## CITY OF CANTERBURY BANKSTOWN

### STORMWATER SYSTEM REPORT 56 Bransgrove Road, REVESBY NSW 2212

Date: 10-Nov-2021  
Ref: WP-SIA-2373/2021  
Development type: **Conversion of existing building to detached building**

**100 Year ARI Flood Extent and Flood Contour Levels  
(mAHD) from Little Salt Pan Creek Catchment  
for 56 Bransgrove Road, Revesby**

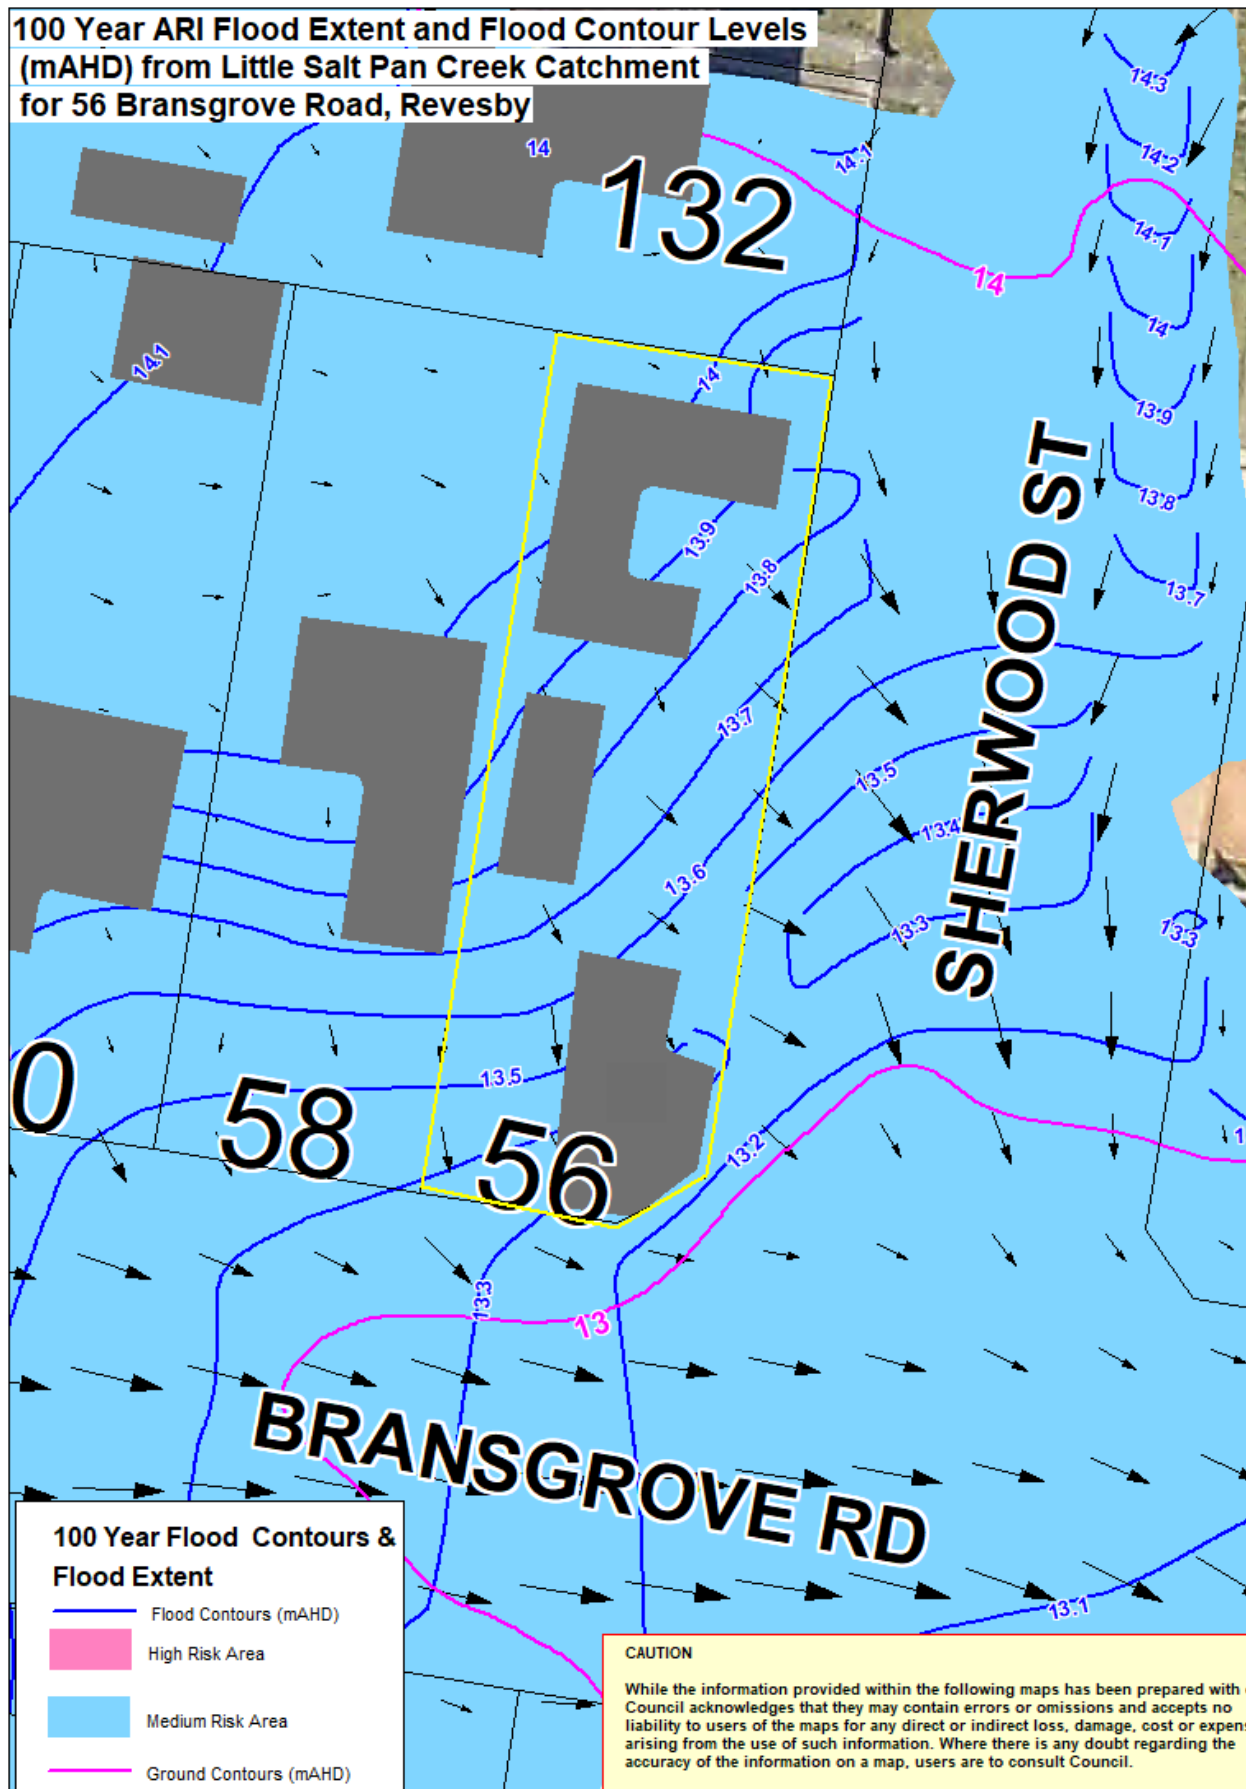
The site will be subject to stormwater inundation from this overland flowpath during large storm events. Refer to the attached "**100 Year ARI & Flood PMF Extent Maps from Little Salt Pan Creek Catchment Study**" showing the flood contours to m AHD\*\*. Provision should be made on site, and at boundary fences, for this stormwater runoff to pass unobstructed over the site. Stormwater flowing naturally onto the site must not be impeded or diverted.

**The estimated 100 year ARI\* flood level at the site is RL 13.9 m AHD\*\* (for rear building).**

**The estimated 100 year ARI\* flood level at the site is RL 13.5 m AHD\*\* (for front building).**

**Habitable floor levels are to be at least 500mm above the 100 year ARI\* flood level at the site adjacent to the proposed buildings.**
